REMARKS

The present amendment is in response to the final Office Action dated May 20, 2011, which set a three-month period for response, making an amendment due by August 20, 2011, and with the initial two-month period for response expiring July 20, 2011.

Fig. 6

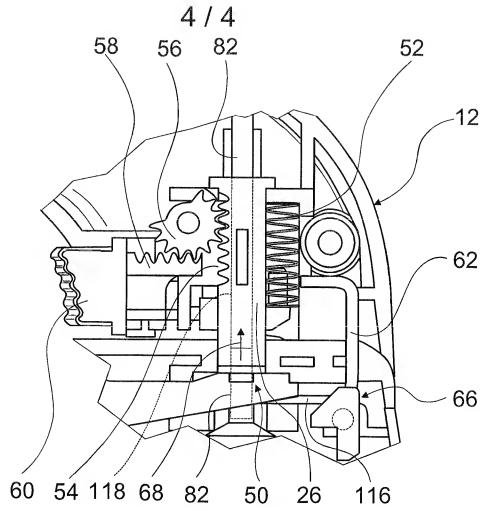
In the final Office Action, claims 13 and 27 were required to be canceled on grounds they are directed to a non-elected invention. Previously withdrawn claims 4-9, 11-23 and 26 were indicated as being rejoined. The drawings were objected to as not showing every feature of the invention specified in the claims, specifically, the "actuator rode guide" of claim 8. Claim 7 was objected to for an informality. Claims 7-9, 16, 22, and 23 were rejected under 35 U.S.C. 112, second paragraph, as being indefinite.

In the present amendment, Fig. 6 has been amended to show the objected-to features of claim 8. The specification was amended on page 8 to refer to the slight change in Fig. 6.

holding mechanism of the attaching device 14 is a hollow locking in 26 forming an actuator rode guide 118 in which an actuator rod 82 of the second on-off switch 18 is guided. Support for these features can be found on page 3, lines 22-29, page 8, lines 17-20, and in prior claims 9 and 23.
